# Msida Creek - Second Round of Feedback

We will be referring to this image as a reference since this includes labels which will enable us to pinpoint problematic areas.

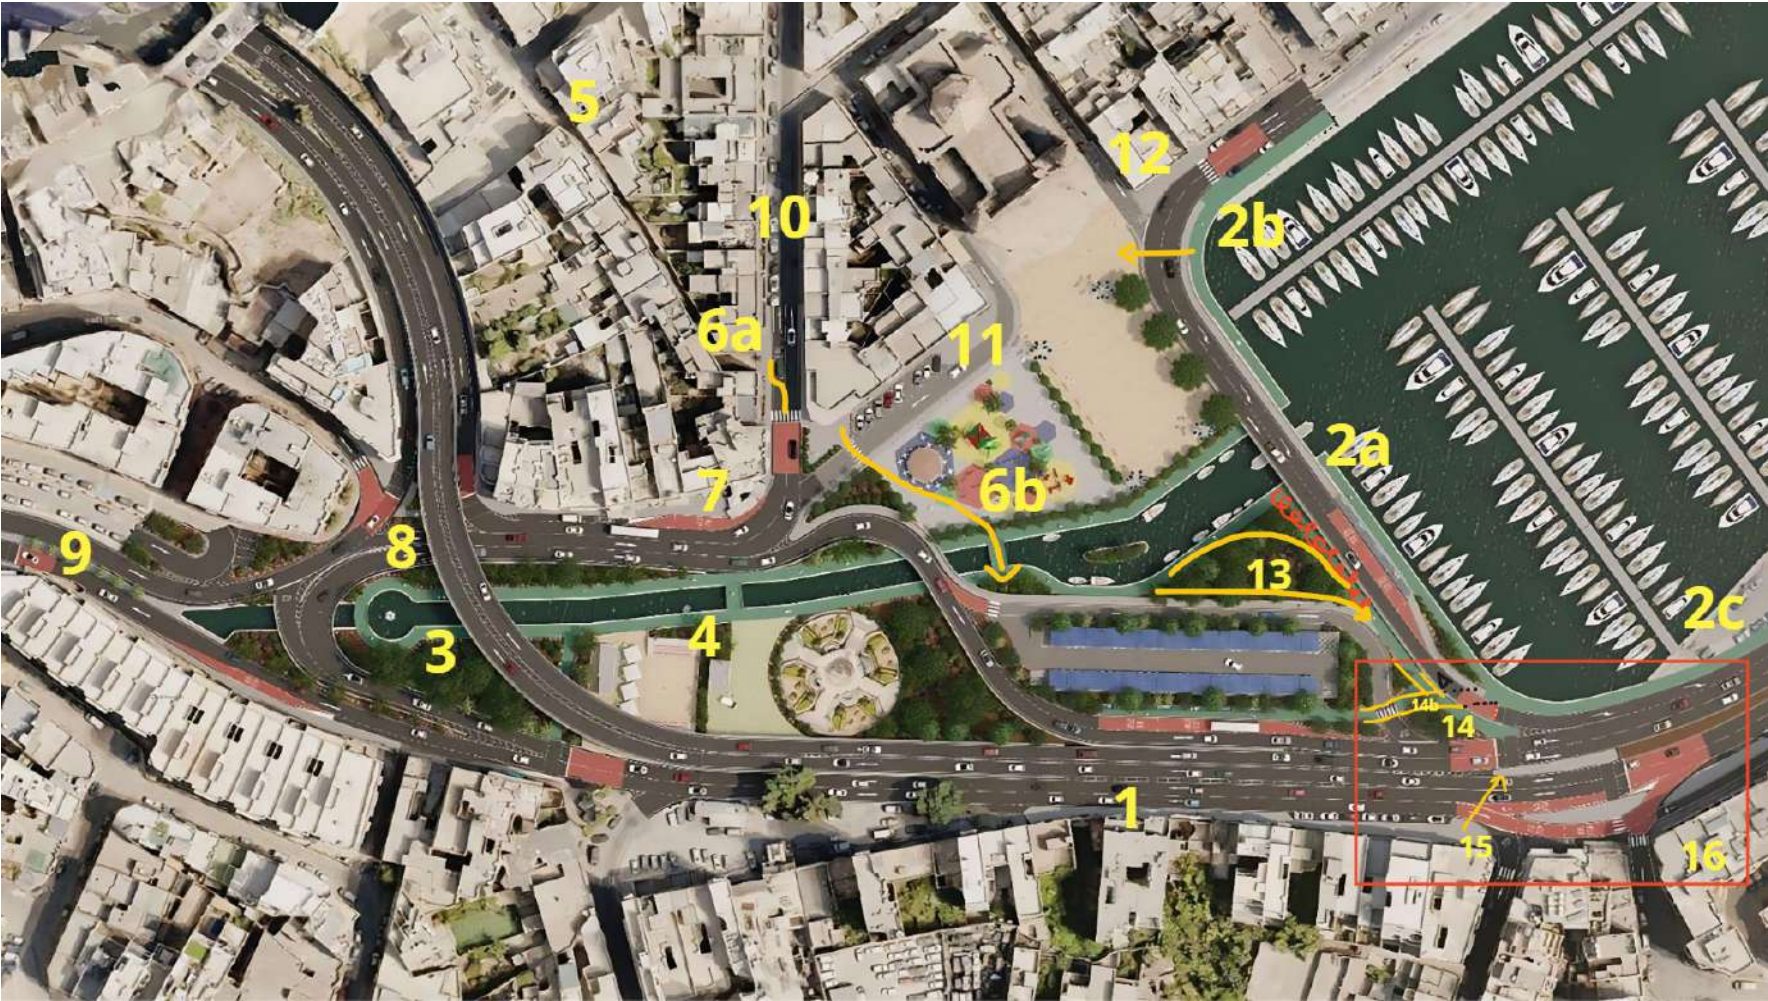
In a 5 car lane street this is unacceptable. The bicycle should not be forced to use pavement to avoid dangerous encounters with cars, unless the pavement is specifically designed for bicycle use.

This is one of the most crucial changes that is needed in this project. There are 5 car lanes in the design. If we shave off 20cm from each, we can win a 1 metre bicycle lane. The wider the better since if we can gain more width we can have the lane segregated. We also highlight that the car lanes do not have to be the same width all the way. It is important to note that research shows that speeding increases with increasing lane widths.

- The Green path by the sea at 2A can be eliminated. Instead of this, we should segregate users to another bridge right next to the one for cars. This can be the same bridge, as long as different traffic is **segregated** completely, and the surface used is different. If we opt for the latter, the current bridge design will need to be widened to allow for more comfortable shared space. However, we recommend having a separate bridge since this is safer. We make reference to the pedestrian bridge near AUM in Birgu. Such a design for users will be the ideal option. This will allow more directness for pedestrians and bicycle traffic, and more comfort since it is elevated and will also be more difficult to flood when it rains.

- The adoption of the previous point will allow the removal of the green path underneath the bridge, which is prone to flooding and is not direct. This path also contains blind corners

(90 degree corners) which poses a risk for users, since you never know if a bicycle is approaching. Research also shows that such scenarios are especially scary for female users, so we should avoid such corners. The route should be visible at all times. We have also seen the problem in the Msida skatepark subway (after which mirrors were retrofitted).

- After the Zebra crossing at 2B (going towards 2A), the car lanes should be one lane since it closes up to one lane anyway at the end of the bridge. This will allow more space for the pedestrian bridge.
- The bus stop on the bridge can remain as is, or else shifted to 2B.

While the pedestrian path extends up to here, we have some concerns over the water quality here. Will there be a pump to move the water? If not, a number of people have voiced concerns over the smell and quality of the sea water that will collect here. They have also raised concerns over the fact that any waste carried by rainwater will be deposited here. A suggestion we've received is to collect rainwater in reservoirs rather than throw it out to sea, which will in turn be used to water all the plants and trees in the area.

A crossing from Point 7 to Point 4 will be ideal for users to provide more directness.

In our last meeting you suggested a route to University through this area. We reiterate that if alternative routes are suggested, signage is included from before and throughout the route to make sure it is easily accessible by users.

However, the most direct, obvious and cohesive route is from the bypass at point 8. There is ample space right now for a bicycle lane on both sides of the roads.

We've illustrated at point 6A that the pavement should be extended (marked with orange) so users coming from Point 5 have ample space to turn and reach the zebra crossing at 6a. The route should connect well to the bridge at point 6B. In the proposed plans, the orange arrow at 6b is not possible, but with this small intervention it can be made more accessible.

The pavement here can be extended further rather than having the extra hard shoulder for the bus lanes (which is illustrated as a very narrow red area). On the plans this is marked as an unloading bay area, can you confirm if this will remain as a bus stop please? This area also needs to be connected to point 4 as explained previously.

This is another ideal location to introduce a crossing to enter the green pathway for users coming from the other side of the road.

If this area is within the project's scope, can space be rearranged here to make room for safe bicycle access?

This road is currently used as a very wide single car lane with parking on the side. We note that this can be improved for users by

extending the pavements and installing a bicycle lane and slow traffic.

We took note of this point to confirm if the muted gray areas make use of cobblestones since these are a good way of slowing down traffic.

This is an ideal location for bicycle racks.

For this point, we propose that trees are shifted towards the bridge (marked in red) so users can have direct access along the path (marked with an orange arrow). The orange line also shows a curved path which can be used as an alternative, which also avoids having a blind corner. This makes this portion of the project more user-friendly.

The current design includes a 90 degree turn (14B) for users, which is not comfortable for bicycle users, especially with oncoming foot or bicycle traffic. Hence, we suggest a small intervention which straightens the path, extending it as a slanted crossing to the other side (illustrated in black dots). This improved the overall experience of all users making use of this junction.

A crossing at point 15 would offer the most direct crossing, given the current design. One note on this, which we will delve deeper in the following feedback, is that the currently existent crossings from the side of Junior College to the marina will not improve at all with the newly proposed project. As commented in the beginning, area 16 (marked with a red bordered box) is frequented by thousands of users on a daily basis. What can be done to improve the experience of users at these crossings? How can we make the crossing more direct and comfortable for users?
